DART AEROSPACE LTD		Work Order:	85874
Description: Crosstube Assembly (205/212 High Aft)		Part Number:	D212-664-241
Inspection Dwg: D212-664-241 Rev: D		Page 1 of 2

DRAWING NO. D212-664-241	TITLE CROSSTUBE ASSY (205/212 HI AFT)	REV. D	DART AEROSPACE LTD ENGINEERING ORDER		D.E.O. NO. D212-664-241-D-1	SHEET NO. SHEET 1 OF 2	SCALE NTS
DRAWN	CHECKED	MFG. APPR.	APPROVED	DE APPR.			
DATE 11.04.07	DATE 11.04.11	DATE 11.04.12	DATE 11/04/12	DATE 11.04.12

DRAWING NO. D212-664-241	TITLE CROSSTUBE ASS'Y (205/212 HI AFT)	REV. D	DART AEROSPACE LTD ENGINEERING ORDER	D.E.O. NO. D212-664-241-D-2	SHEET NO. SHEET 1 OF 1	SCALE NTS
DRAWN <i>Q</i>	CHECKED <i>ASS</i>	MFG. APPR. <i>B</i>	APPROVED <i>MD</i>	DE APPR. <i>#</i>		
DATE 11.07.15	DATE 11.07.20	DATE 11.07.21	DATE 11.07.21	DATE 11.07.21

D212-664-241/-241B
ASSEMBLY DETAIL

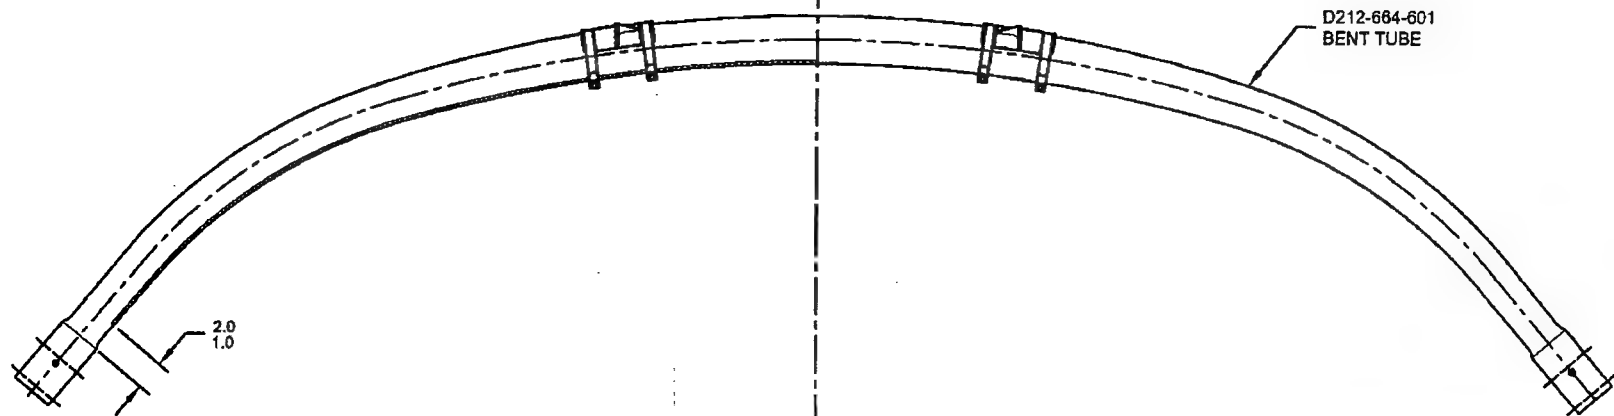
PURPOSE:

ADD AN INSPECTION WINDOW TO UNDERSIDE OF CROSSTUBE.

NOTES 2 OF SHEET 1 IS AMENDED AS FOLLOWS:

- 2) FINISH: CHEMICAL CONVERSION COAT PER DART QSI 005 4.1
PRIME INSIDE AND OUTSIDE PER DART QSI 005 4.2
MASK UNDERSIDE OF CROSSTUBE AS SHOWN (HATCHED AREA) AND
PAINT OUTSIDE PER DART QSI 005 4.2
REMOVE MASKING AND APPLY CLEAR COAT

- 2) FINISH: CHEMICAL CONVERSION COAT PER DART QSI 005 4.1
PRIME INSIDE AND OUTSIDE PER DART QSI 005 4.2
PAINT OUTSIDE PER DART QSI 005 4.2

MASK AREA PRIOR TO PAINTING,
REMOVE MASKING AFTER PAINT
AND APPLY CLEAR COAT
